Jeffrey

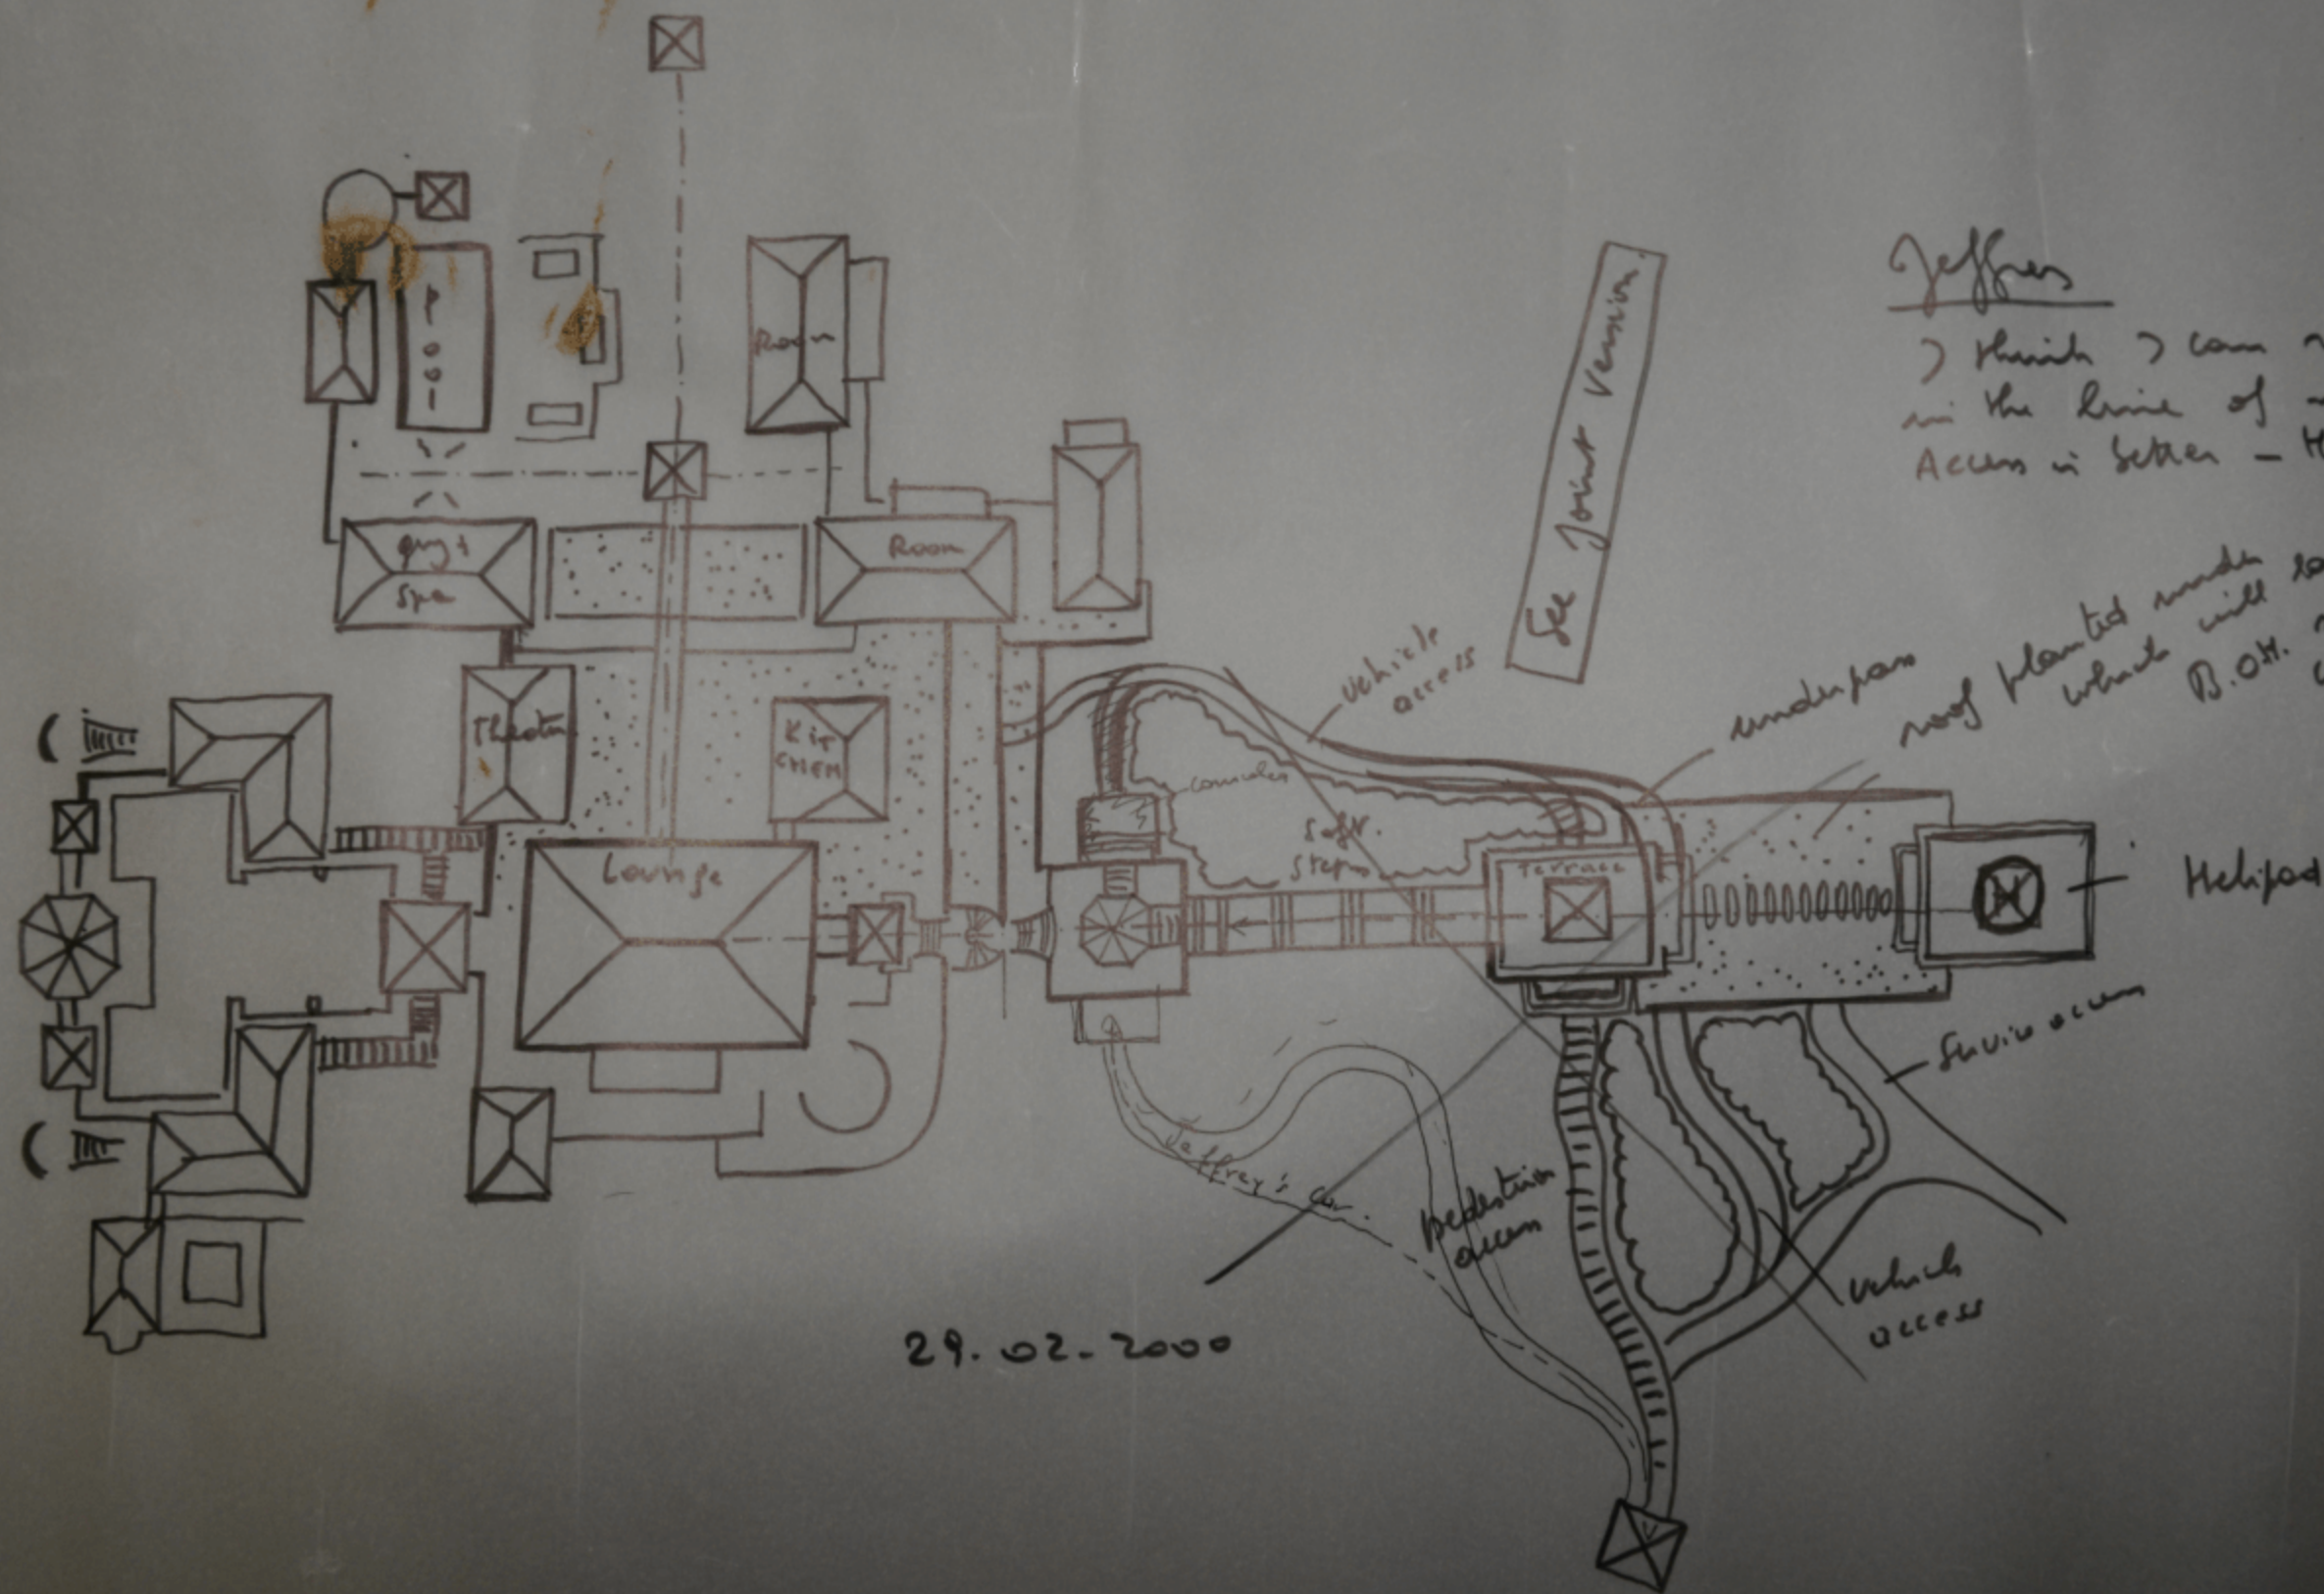
I think I can rework something in the line of my sketch hereunder Access is better - House more compact

underpass roof planted under long the which will B.O.H. confirmed.
